Subject: Final Environmental Assessment (FEA) for Ala Moana Park,
Canoe Halau; T.M.K.: 2-3-037:001
Honolulu, Oahu, Hawaii

2004-11-23 ~~BEA~~ FONSI
ALA MOANA REGIONAL
PARK CANOE HALAU

ALA MOANA REGIONAL PARK Canoe Halau

FINAL ENVIRONMENTAL ASSESSMENT

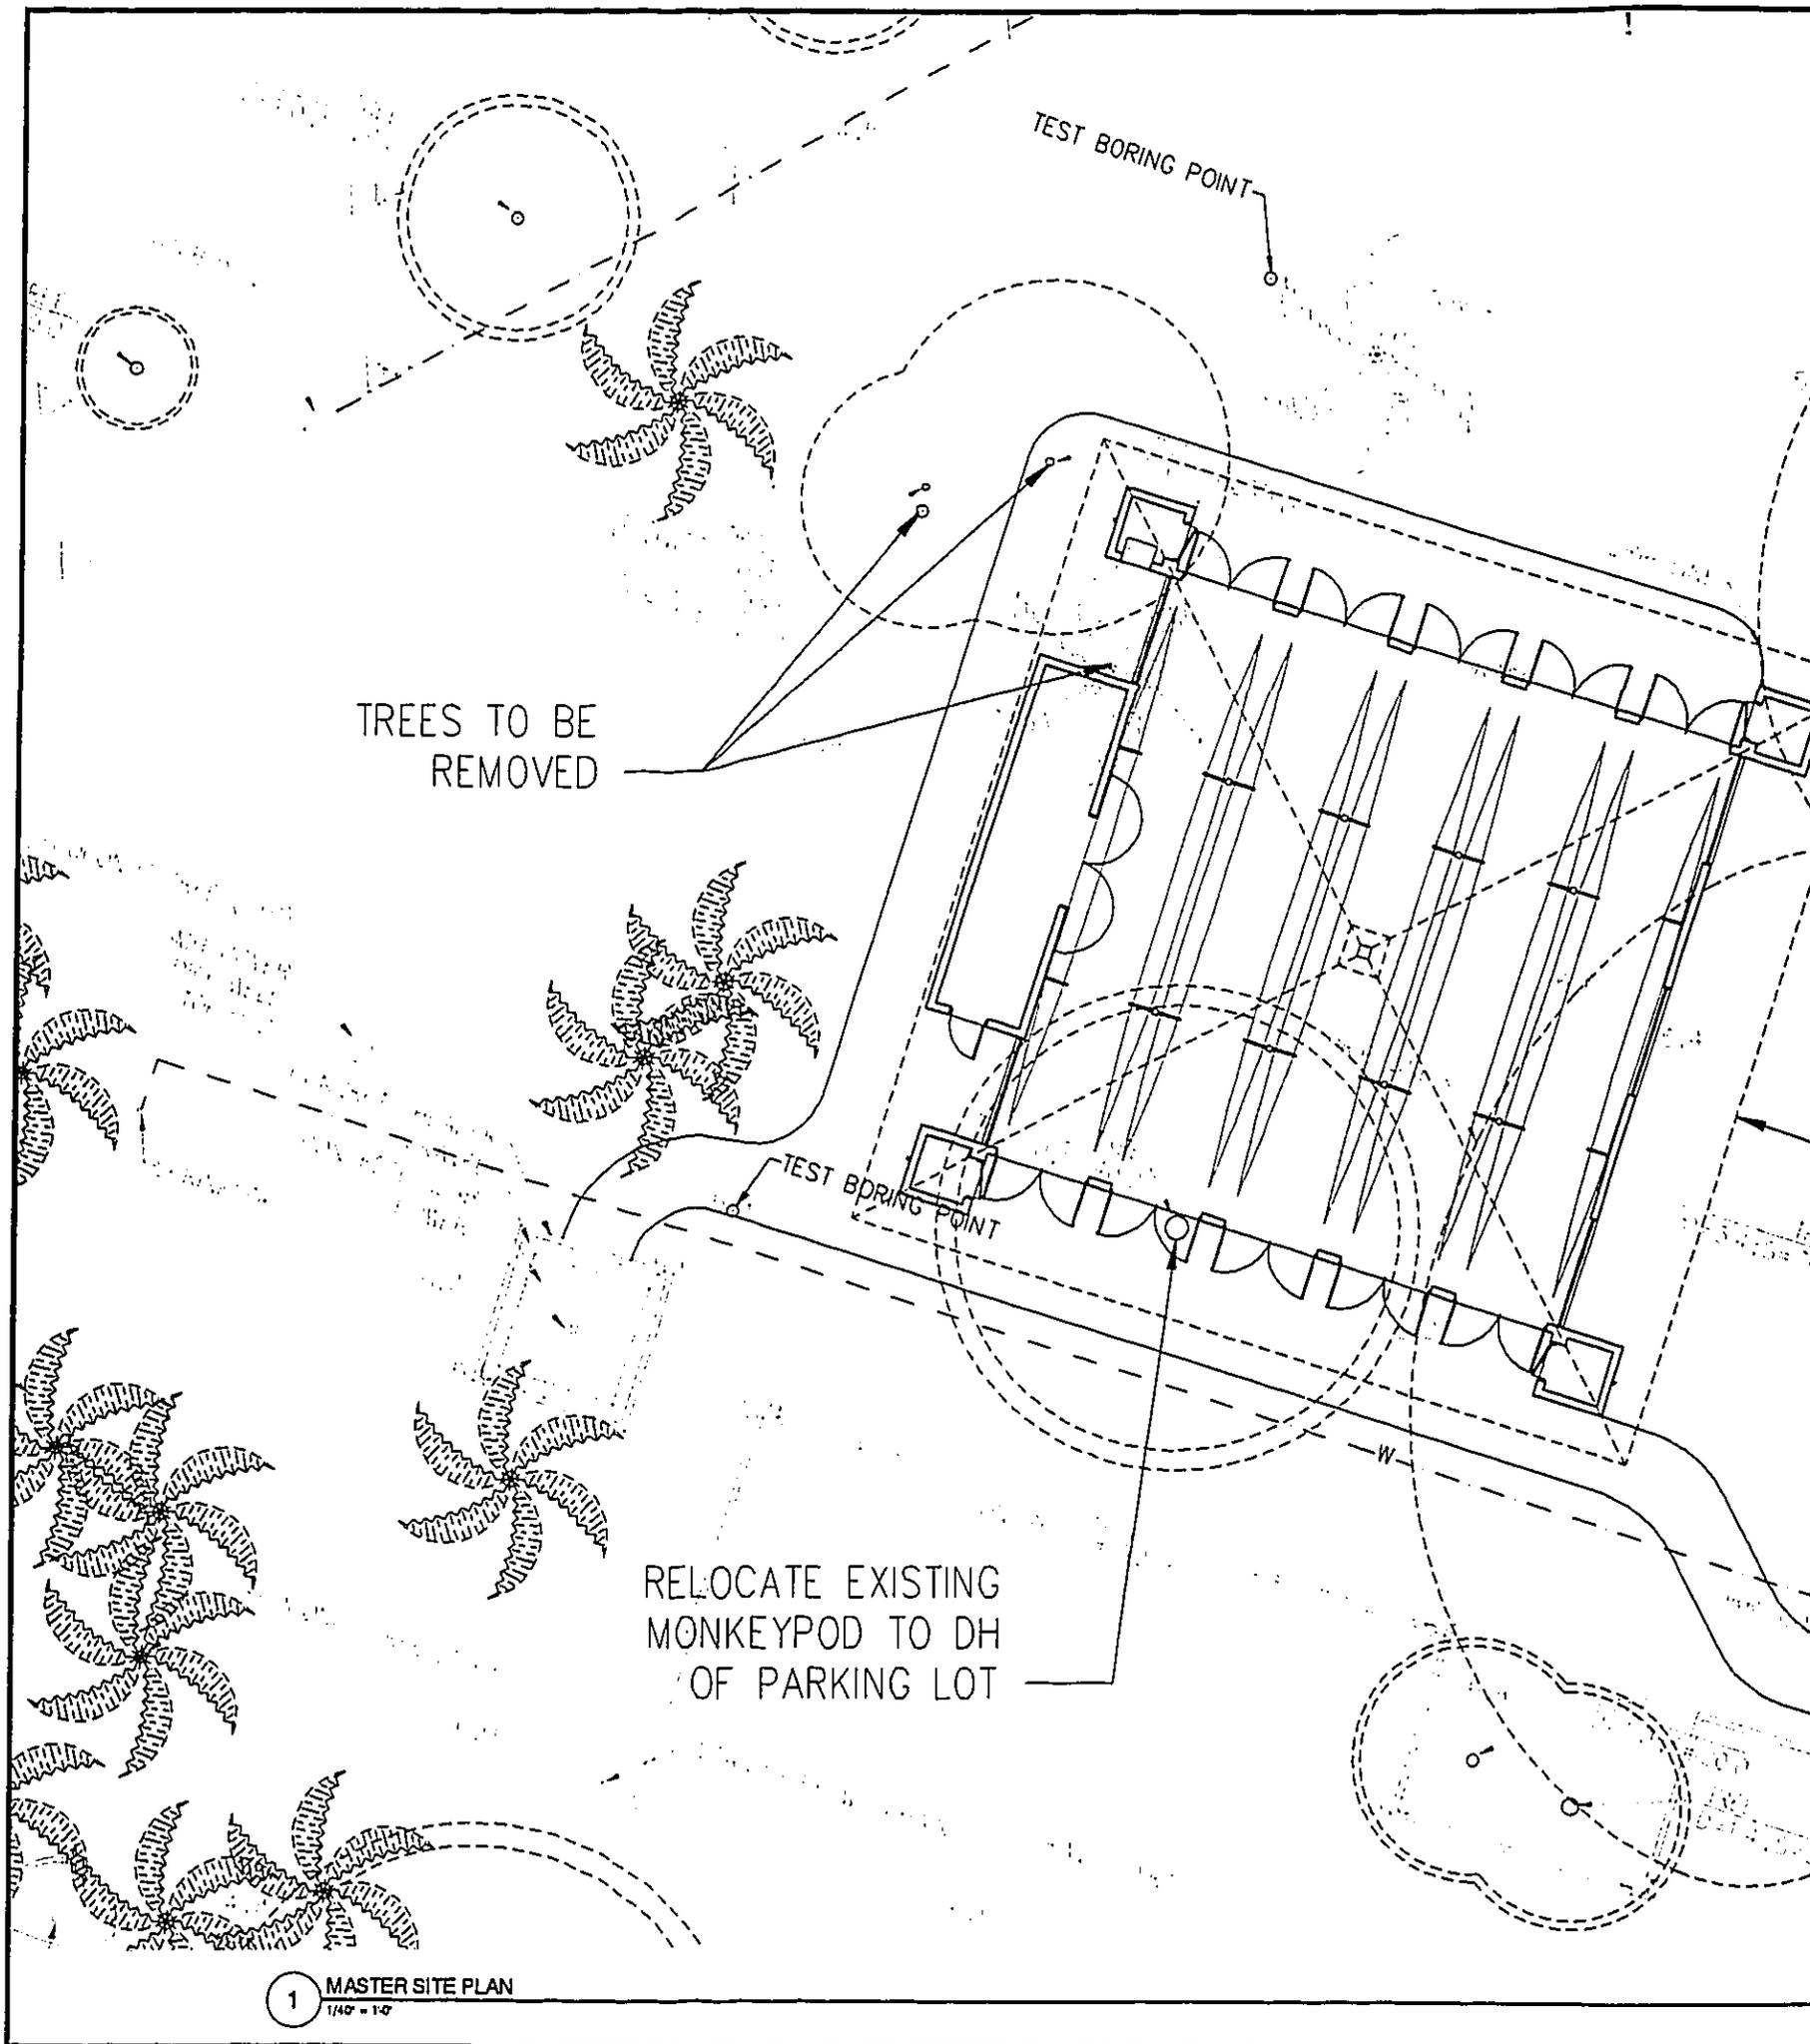
6. The canoe halau site is used by a number of organizations for picnic activities. Page 48 of the EA discusses alternative sites. However, it is difficult to determine the location of these sites. A site plan similar to Figure 5 (Floor Plan) showing these sites would be helpful. Also, the EA should address whether it would be possible to construct the halau on the Waikiki side of the parking lot.

1 BUILDING ELEVATIONS
1/16" = 1'-0"

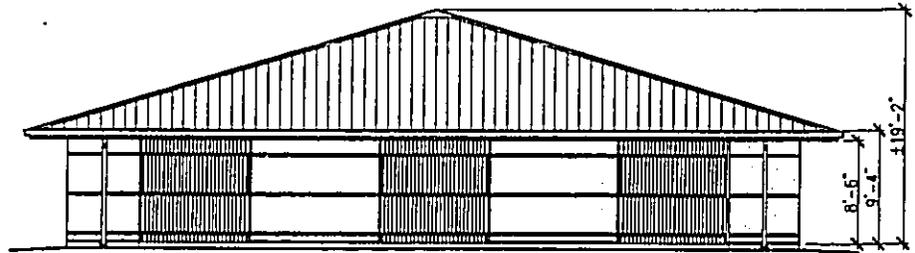
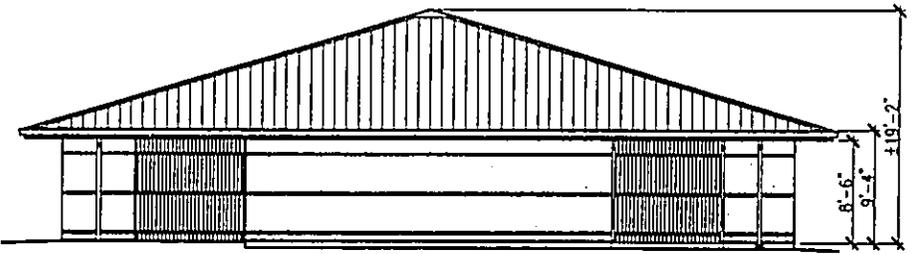
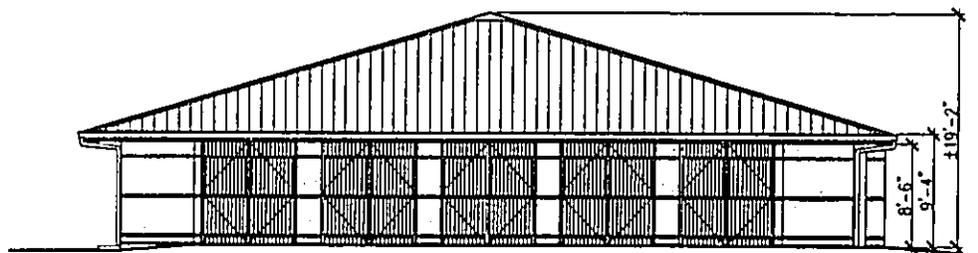
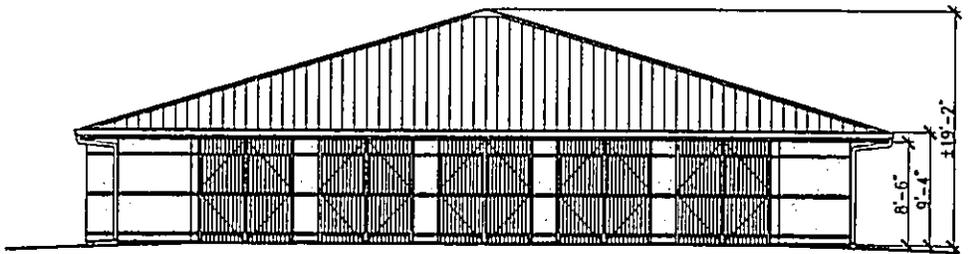
Section 2.4, *Technical Description*, gives the halau height at 19 feet. However Figure 6, *Elevations*, shows the heights of the walls to be 19 feet, excluding the roof. What is the overall height from the base to the top of the roof?

FIGURE 7
SOILS MAP

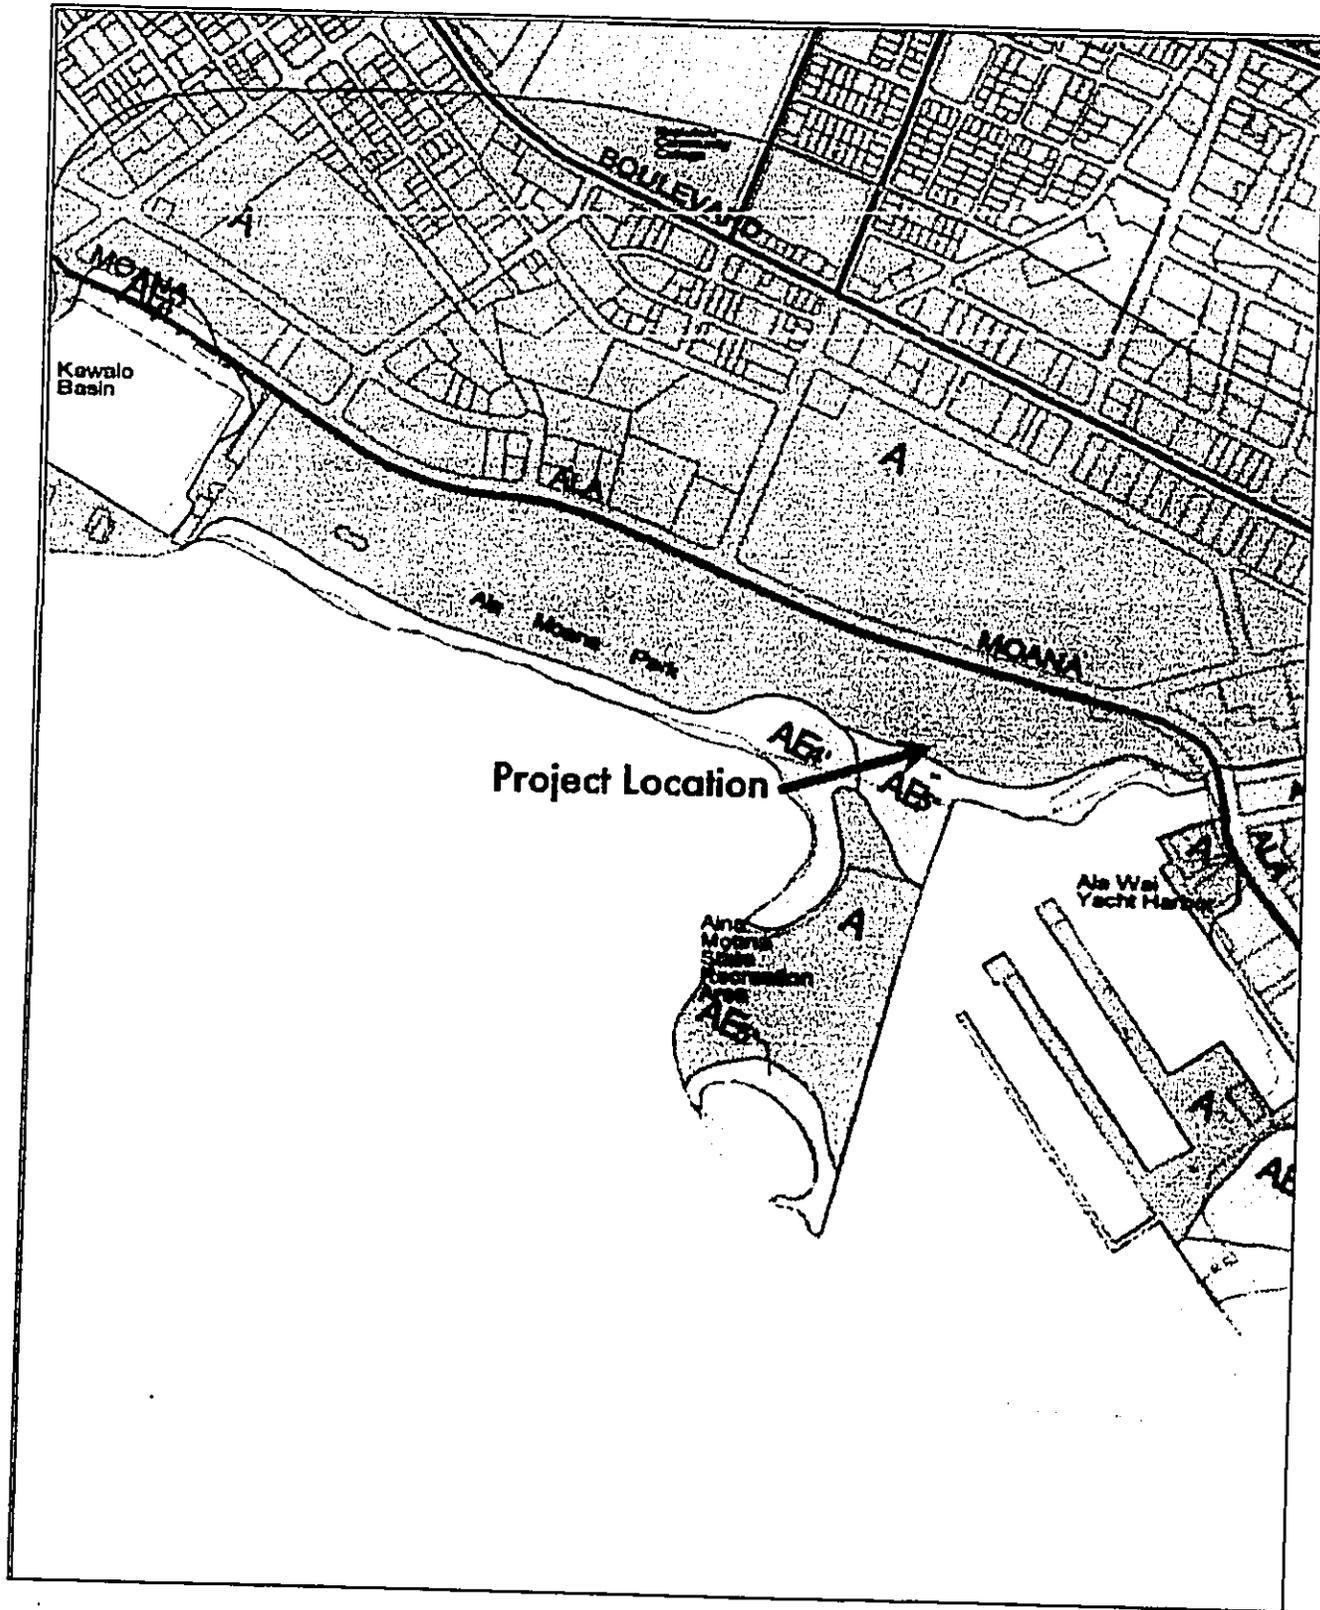
In Figure 7, *Soils Maps*, include a legend which indicates the soil type abbreviations used in the map. These abbreviations do not appear and are not defined in section 3.1.2, *Soil Characteristics and Groundwater*.
